KENNEDALE PLANNING & ZONING COMMISSION
AGENDA
COMMISSIONERS - REGULAR MEETING
March 20, 2014
CITY HALL COUNCIL CHAMBERS, 405 MUNICIPAL DRIVE

To: Rachel Roberts
From: Greg Saunders
cc: KEN 13001
Date: March 5, 2014
RE: **Hilltop Addition Final Plat and Construction Plan Review**

Paving and Drainage Details

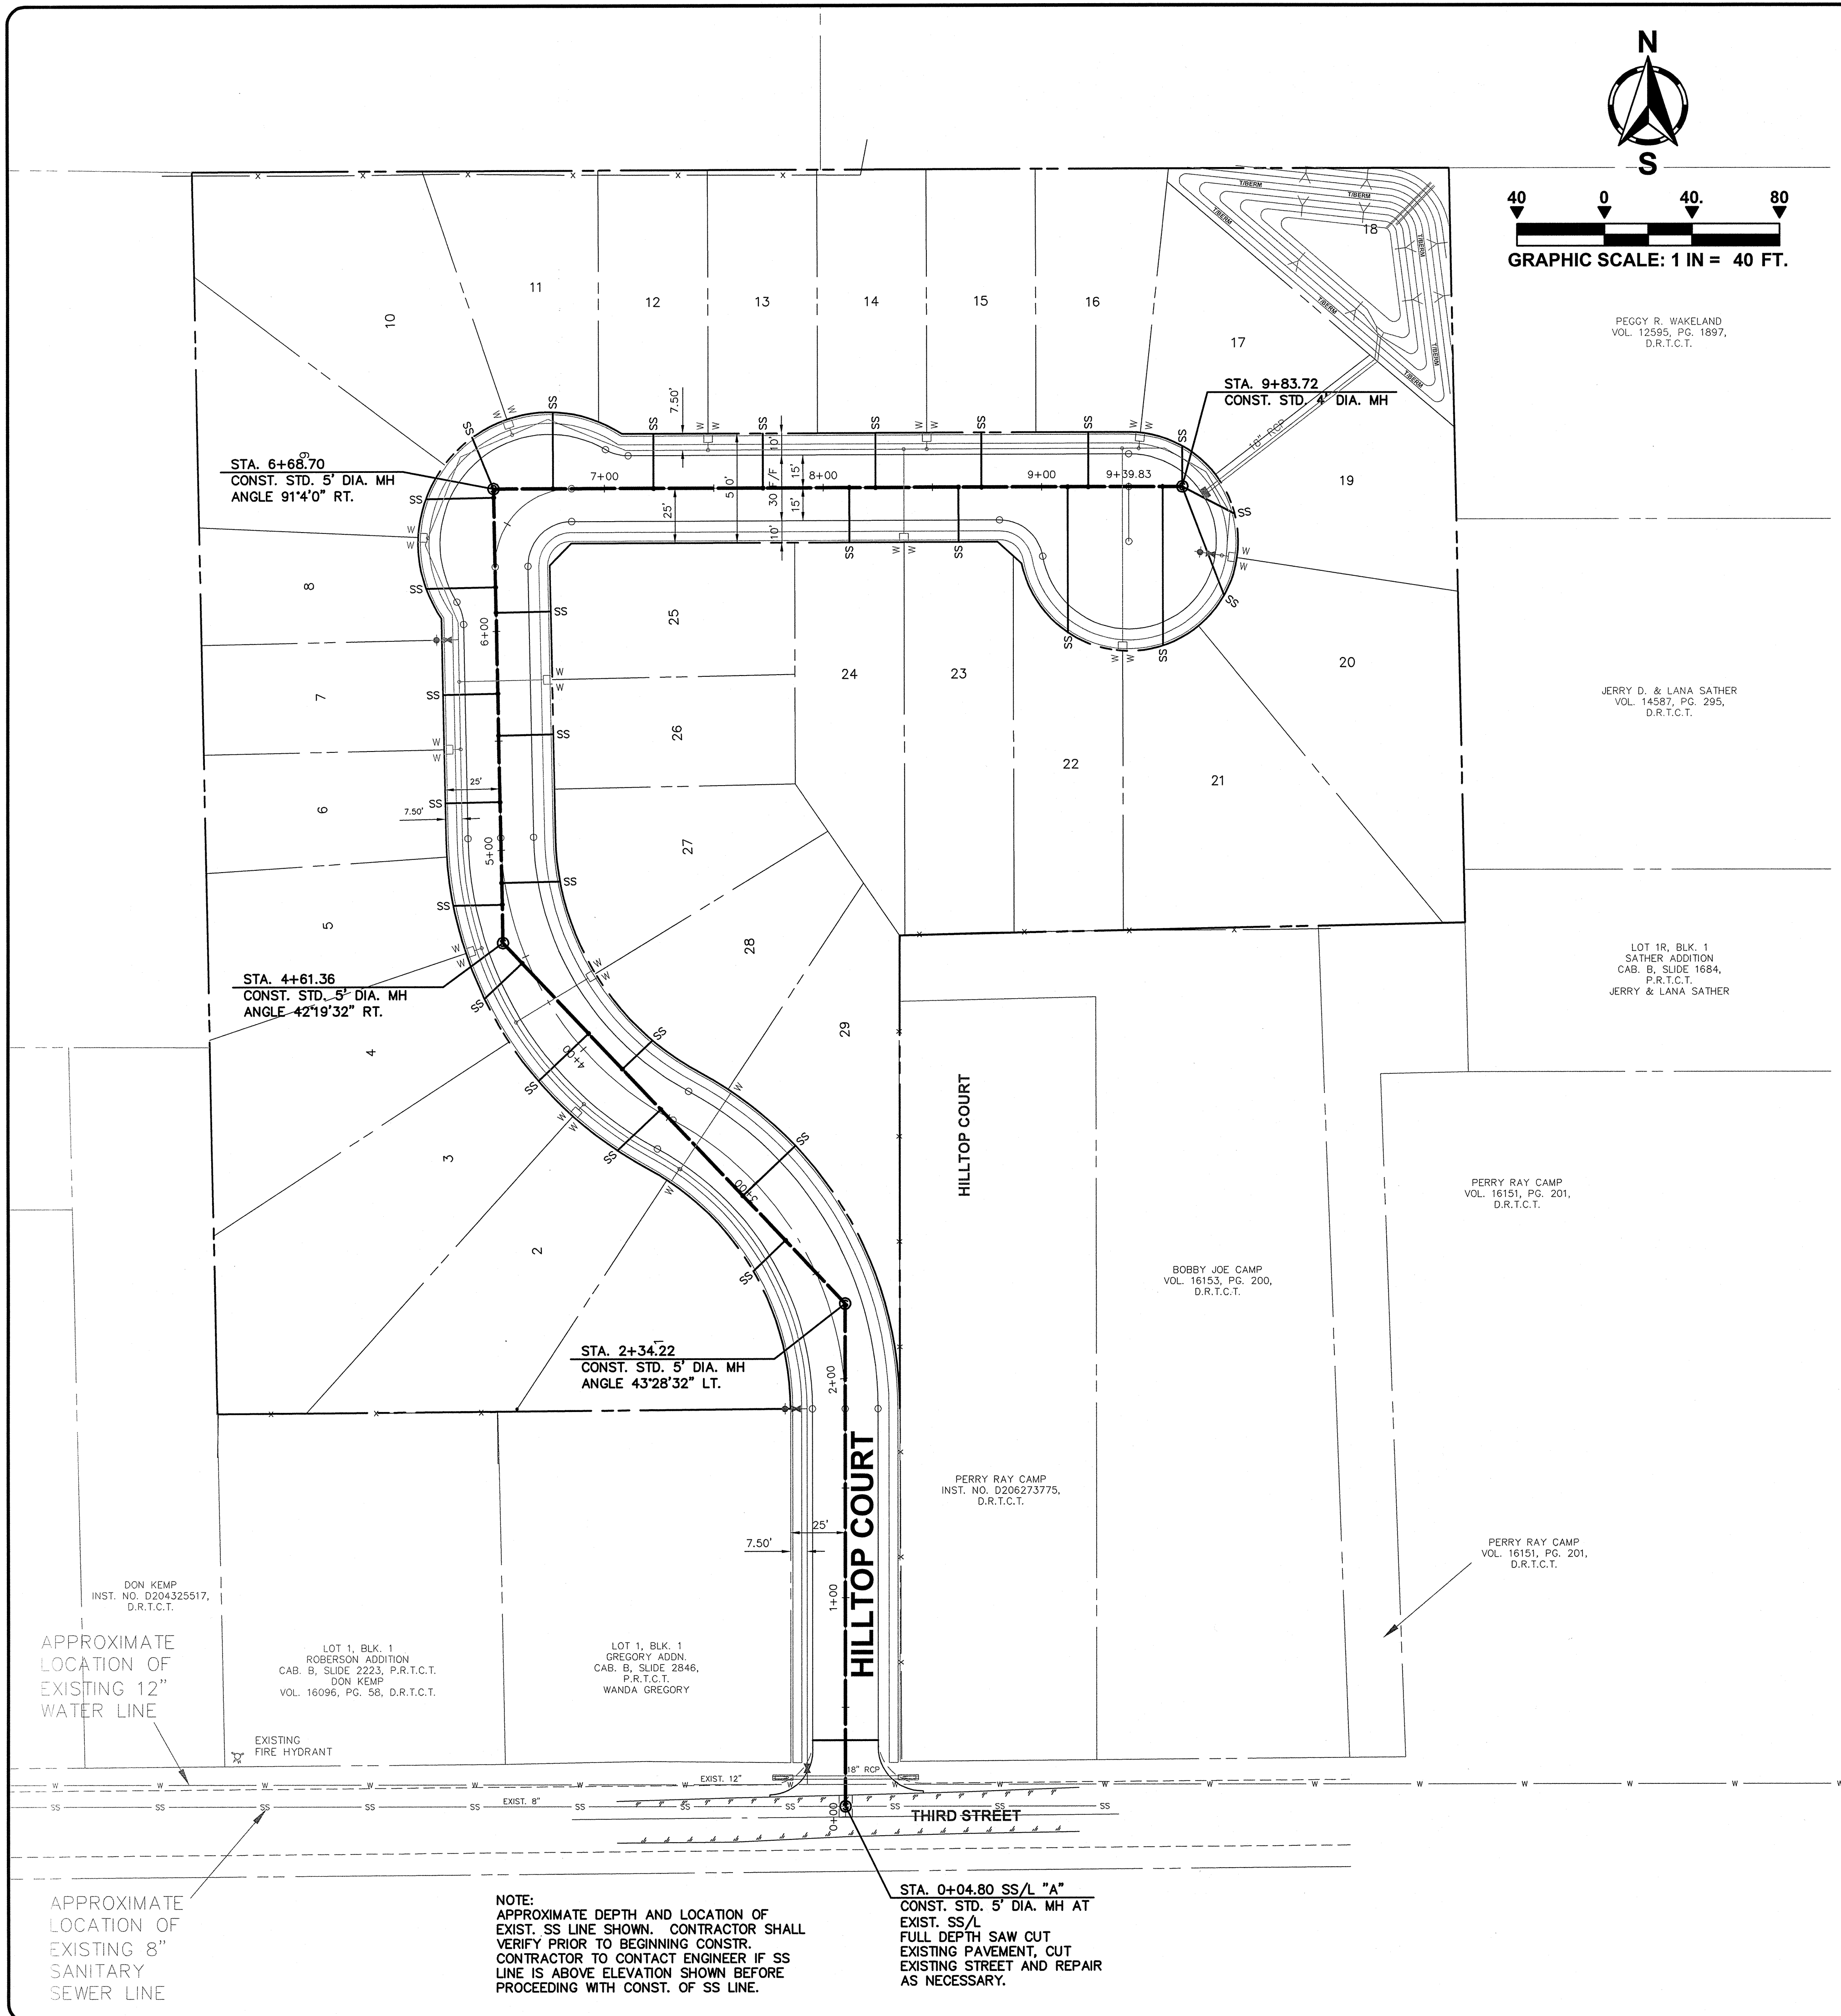
1. Change the Pavement Thickness to 6".
